STAFF REPORT AMENDED 9-8-83
CITY PLANNING COMMISSION

- APPLICATION:
1. Environmental Determination
 2. Special Permit for drive-thru Fotomat kiosk (Section 3-D-7)
 3. Variance to reduce the 50% shading requirement to 30% (Section 6-D-9) (P83-225)

PROPOSAL: Drive-thru for Fotomat kiosk relocated from former Fort Sutter Raley's market site.

EXHIBIT 'A-1'
- APPLICANT'S PLAN

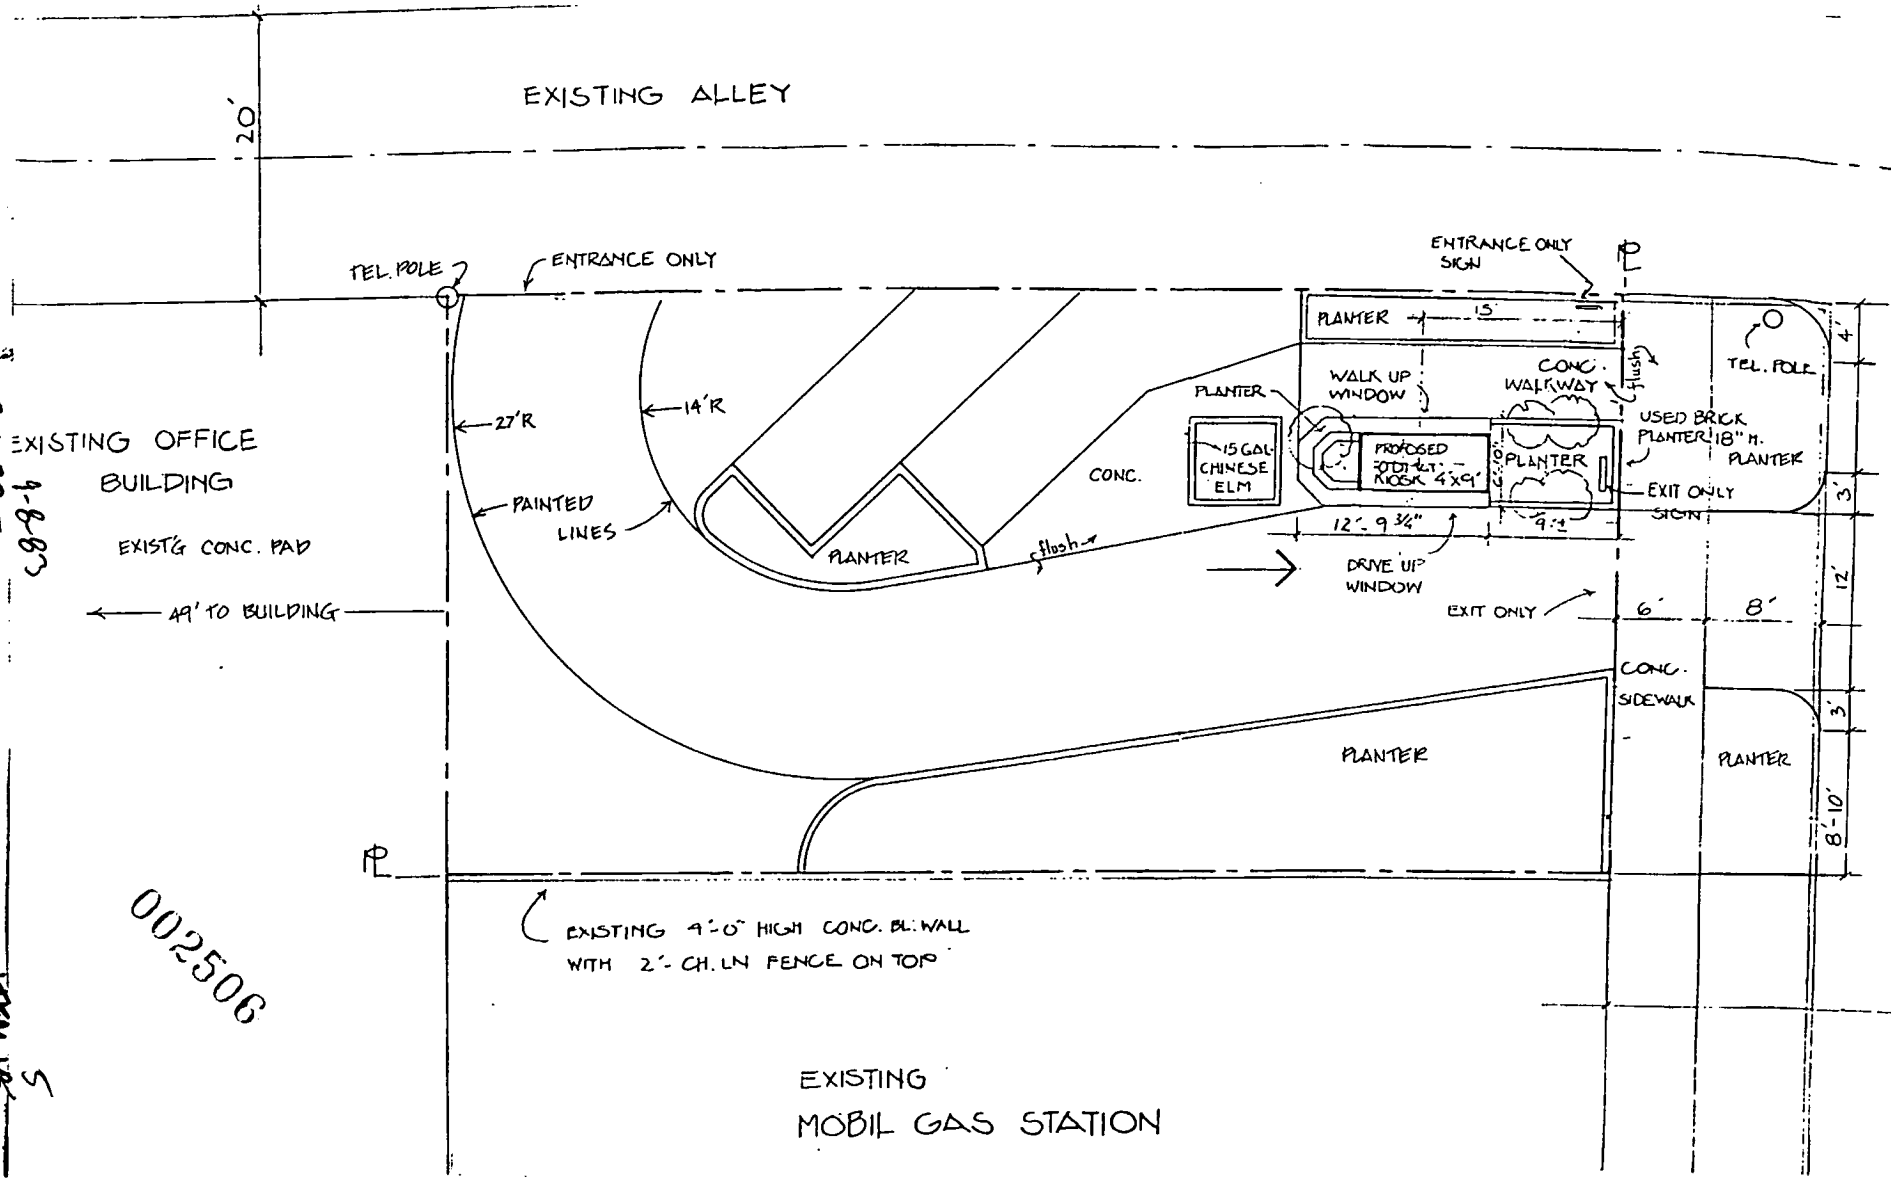
1. The plan reviewed by the Board (Exhibit A-1) reflects changes prompted by earlier discussions with City staff. Vehicle access to the north service window is not provided due to the possibility of vehicles stacking into the public right-of-way of 29th Street. Instead vehicle access to the site is shown from the alley, with drive-up service available at the south window. Vehicle exiting will be onto 29th Street. The north window will accommodate walk-up service only.

2. The deficiencies of the applicant's plan relate to concerns of the Traffic Engineering Division. Traffic comments are as follows:
 - a. There is a need for adequate separation between the proposed exit driveway and the existing driveway of the Mobil gas station to the south.

- b. A vertical street curb must be provided on 29th Street, except at driveways.
 - c. A minimum range of eight to 10 feet of full height vertical curb between the flares of the proposed driveway and the existing Mobil driveway is necessary for proper traffic management.

- d. The minimum acceptable width of the driveway curb cut is 12 feet, plus three feet of flare on each side of the driveway.
 - e. The minimum necessary driveway width at the kiosk is 11 feet.

- f. The proper vehicle turning radius from the alley to the kiosk is 27 feet, outside radius.
3. Staff incorporated Traffic Engineering comments into a Staff Conceptual Plan (Exhibit A-2). This is the plan staff recommended for Design Review/Preservation Board approval. There was a discussion by the Board of the functioning of the on-site parking. Rather than the awkward arrangement of angled parking within the curvature of the kiosk approach lane, it was suggested by one Board member that parking be placed at the extreme rear of the site. This relocation facilitates a better 90° angle parking design.

EXHIBIT 'A-2'

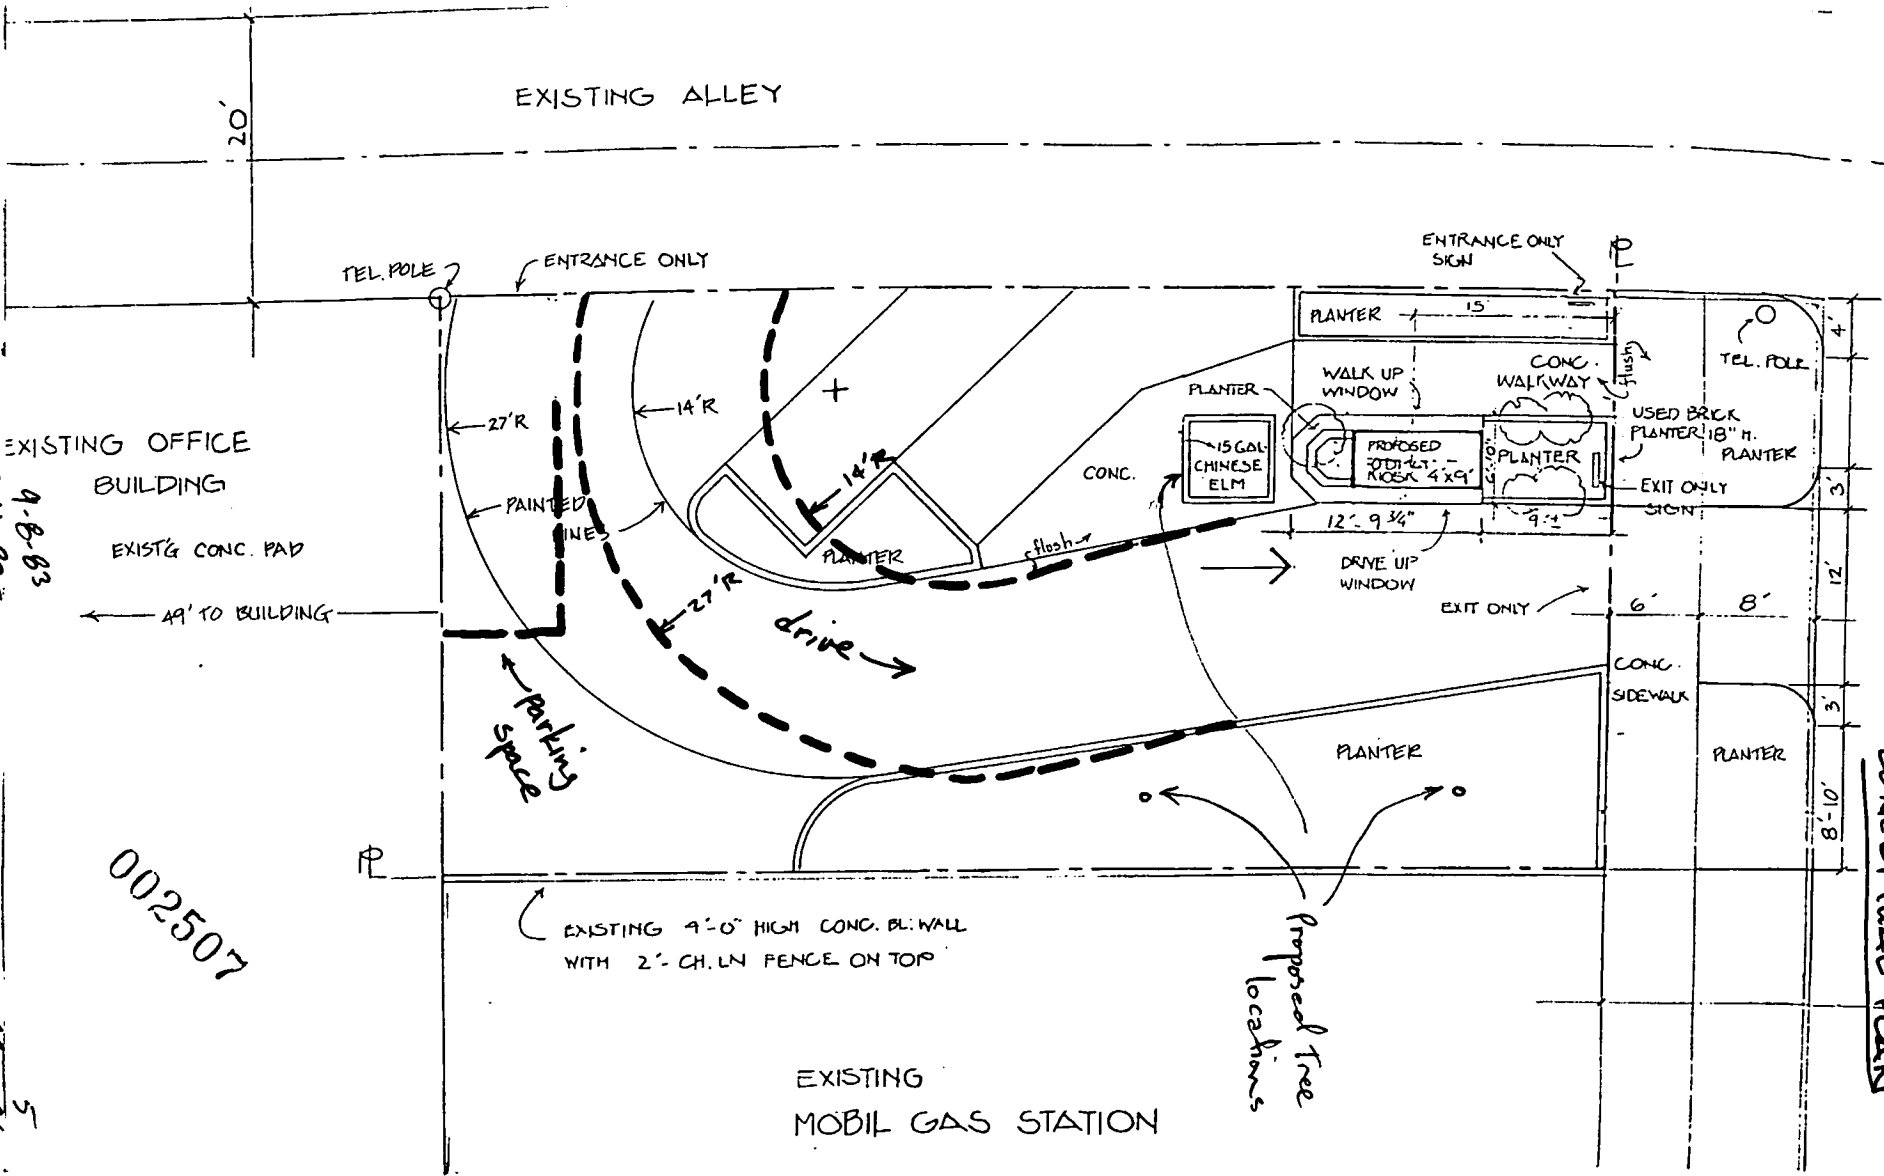
The applicant strongly objects to the size of planter between the approach drive and the southerly property line. This planter was proposed by staff as a more aesthetic alternative to a nonfunctional asphalted surface that would otherwise exist. Additionally, it would be an ideal location for shade trees. Two trees in this planting area (plus the one proposed by the applicant) would create a much more pleasant environment for the kiosk attendant and customers and far exceed the City's shading requirement.

Proposed
EXHIBIT A-3'
 MODIFIED STAFF
 CONCEPTUAL PLAN

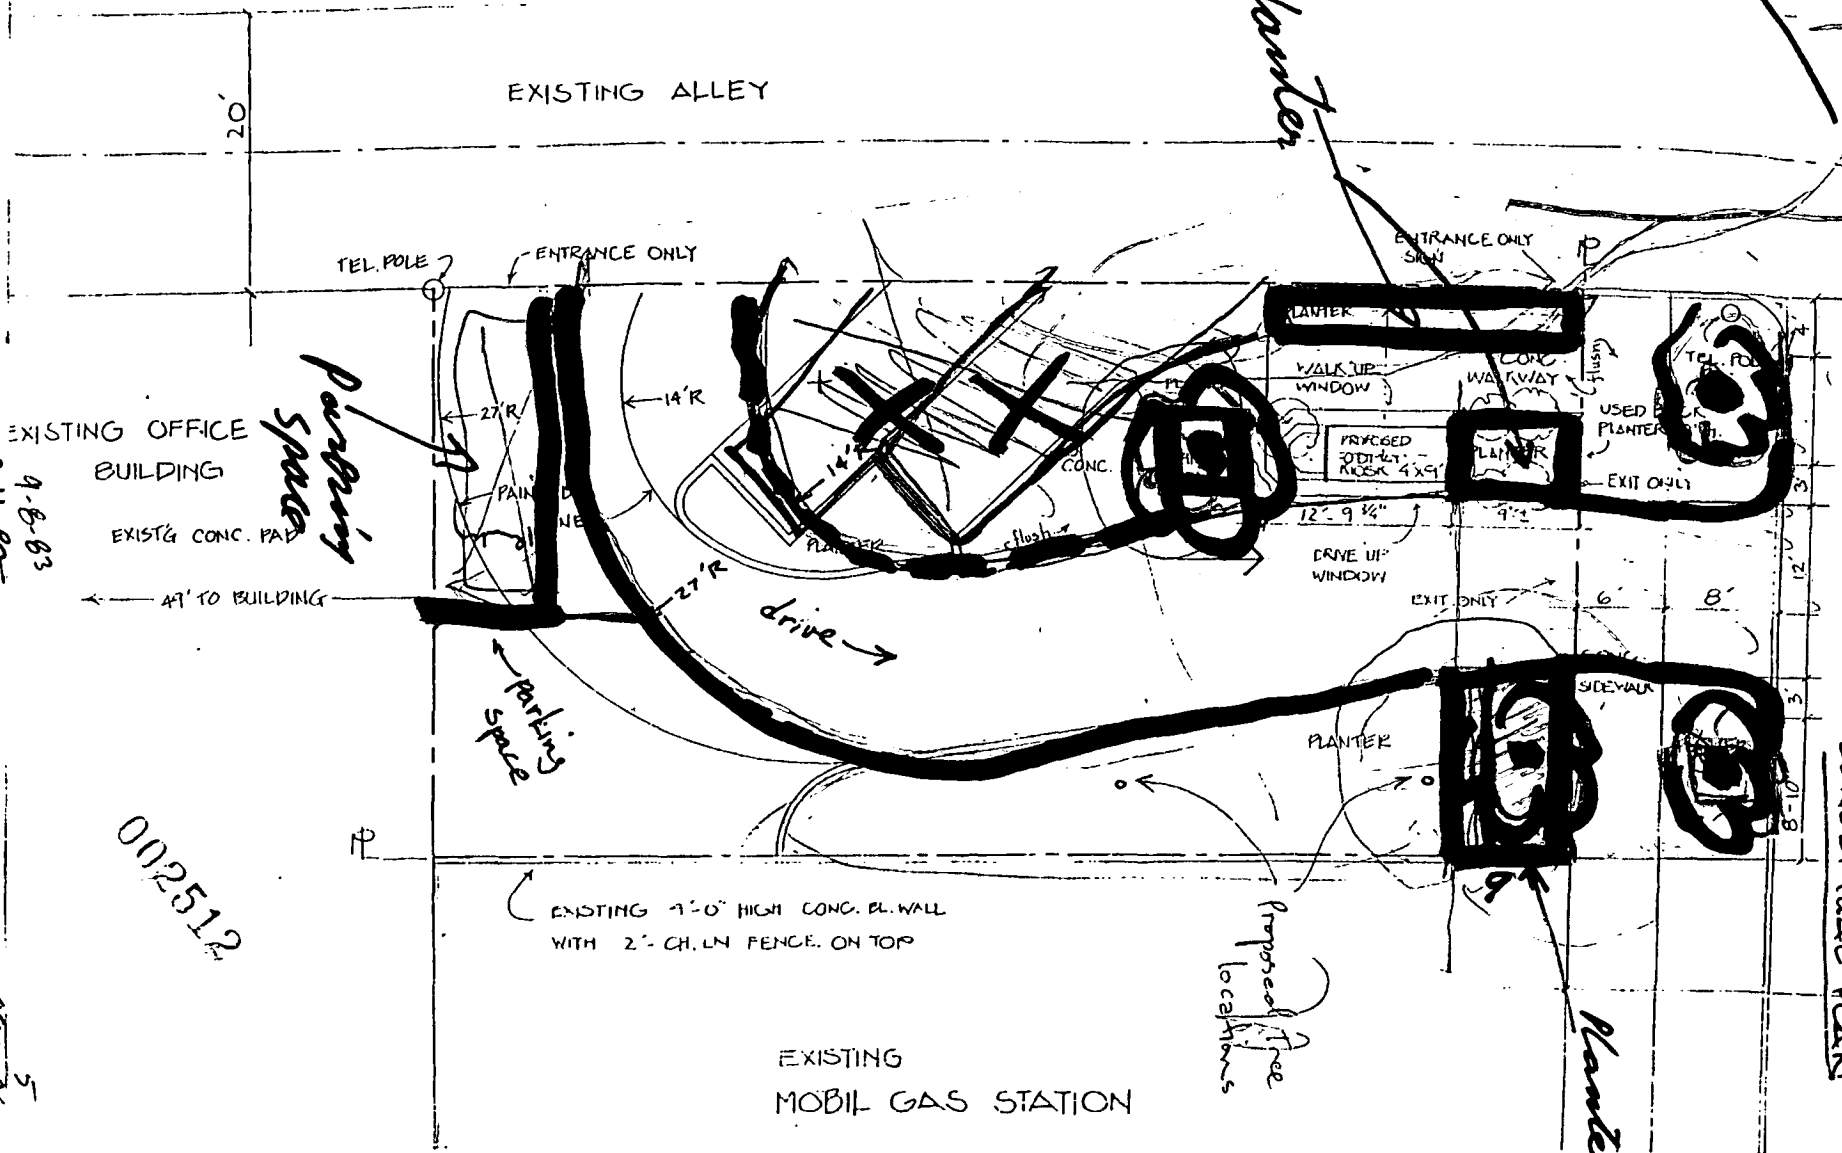
Not until the staff conceptual plan had been prepared was staff advised of the intent of Fotomat to relocate in two years to a proposed new office building nearby. Staff considers the on-site improvements shown on the "Modified Staff Conceptual Plan" as reasonable and appropriate, particularly for a Central City location and regardless of the planned two year life to the facility. Furthermore, the value of such trees aesthetically and as shading may extend beyond the life of the Fotomat kiosk, possibly fitting into the tree shading scheme of a future use of the property.

The applicant would exclude planting on the alley side of the kiosk. The result would be a less aesthetic appearance in comparison to staff's latest proposal (see Exhibit A-3). More importantly, the lack of the planter proposed by staff could facilitate a haphazard driveup or parking area in which the vehicle would likely overhang onto the alleyway. This hazardous situation is illustrated on Exhibit A-5.

- a. Parking and on-site circulation shall be provided according to the modified staff conceptual plan (Exhibit A-3). *(CPC approved as per revised Exhibit A-3)*

EXHIBIT 'A-4'
 * APPLICANT'S REVISED PLAN

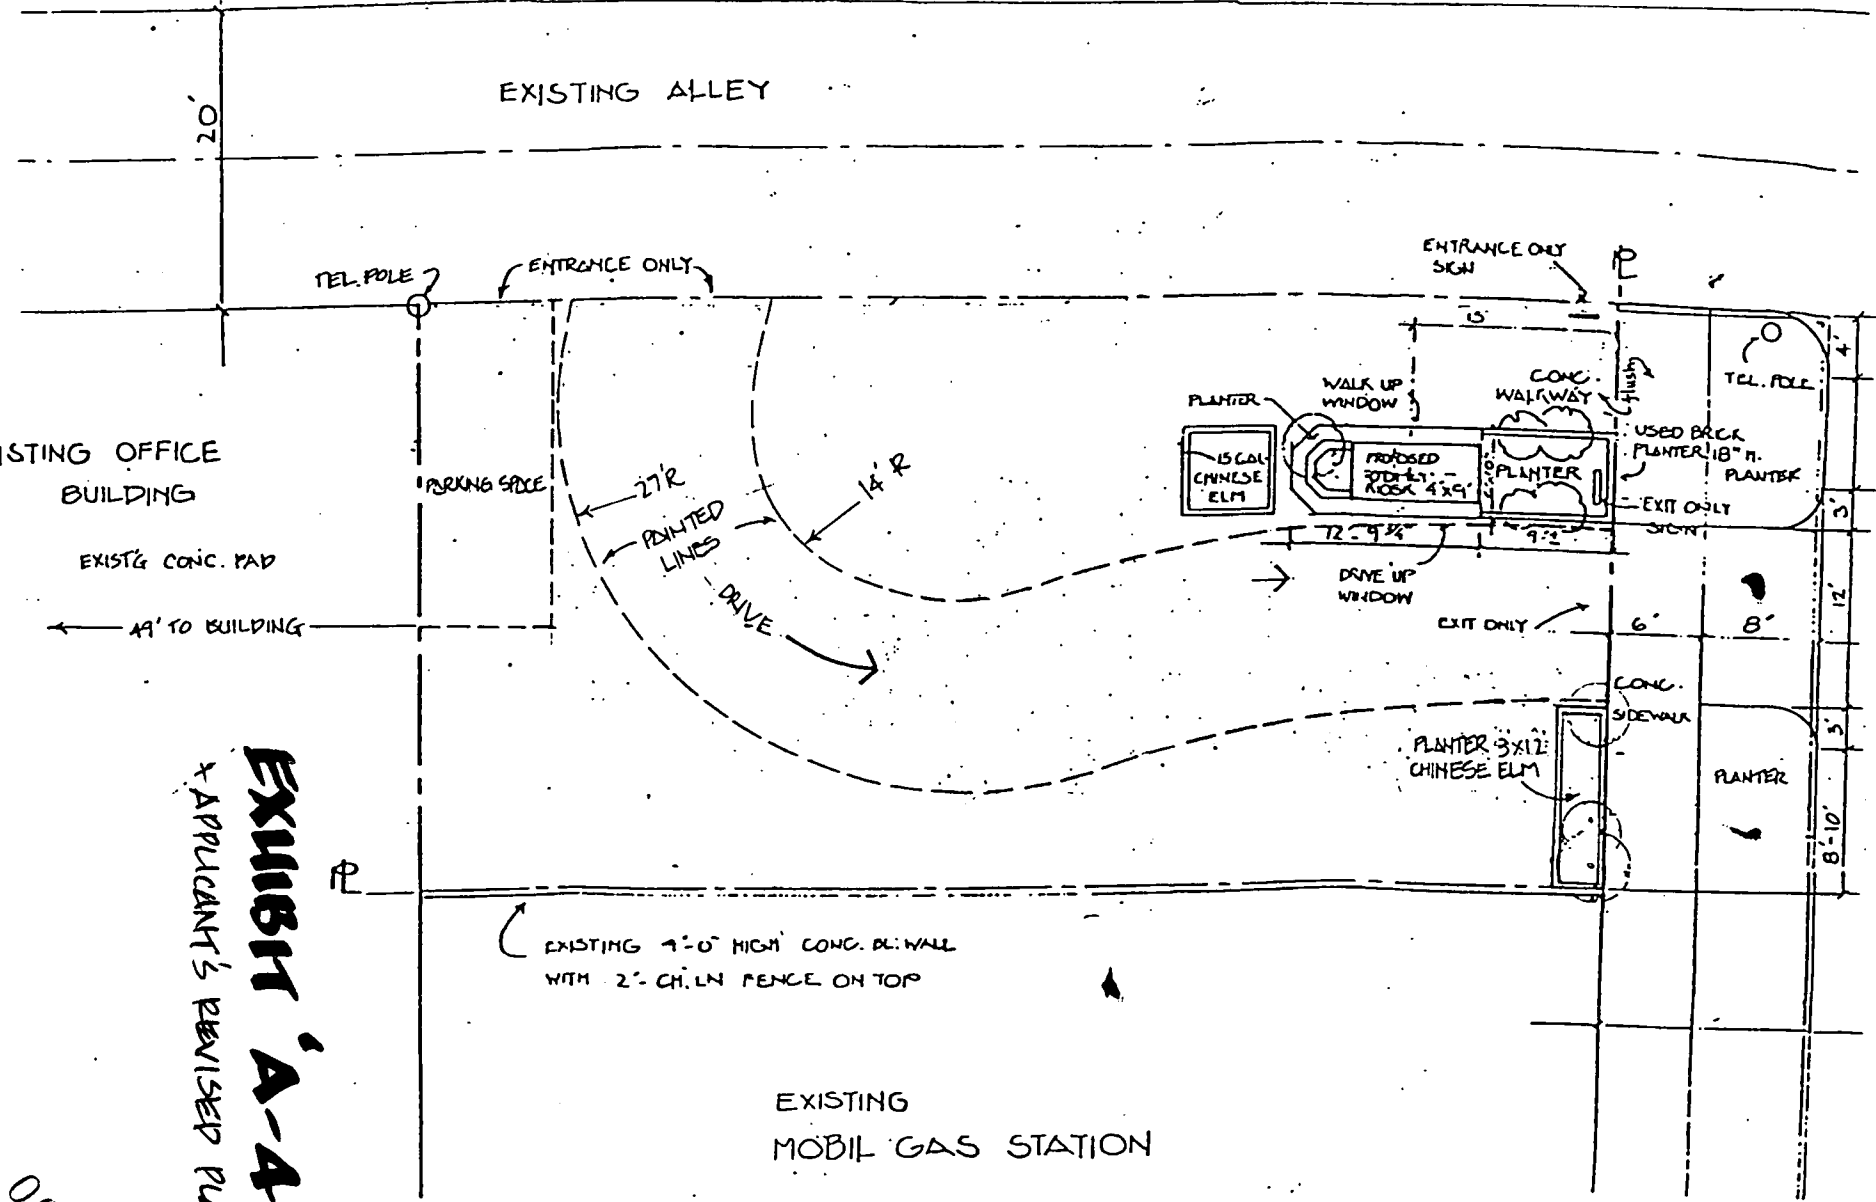
6. The applicant has submitted a revised plan (see Exhibit A-4) as a counter proposal. The applicant proposes a standard four foot planter in back of the public sidewalk in place of the larger planter proposed by staff. A six foot wide planter is the minimum size that would support a Chinese Elm.
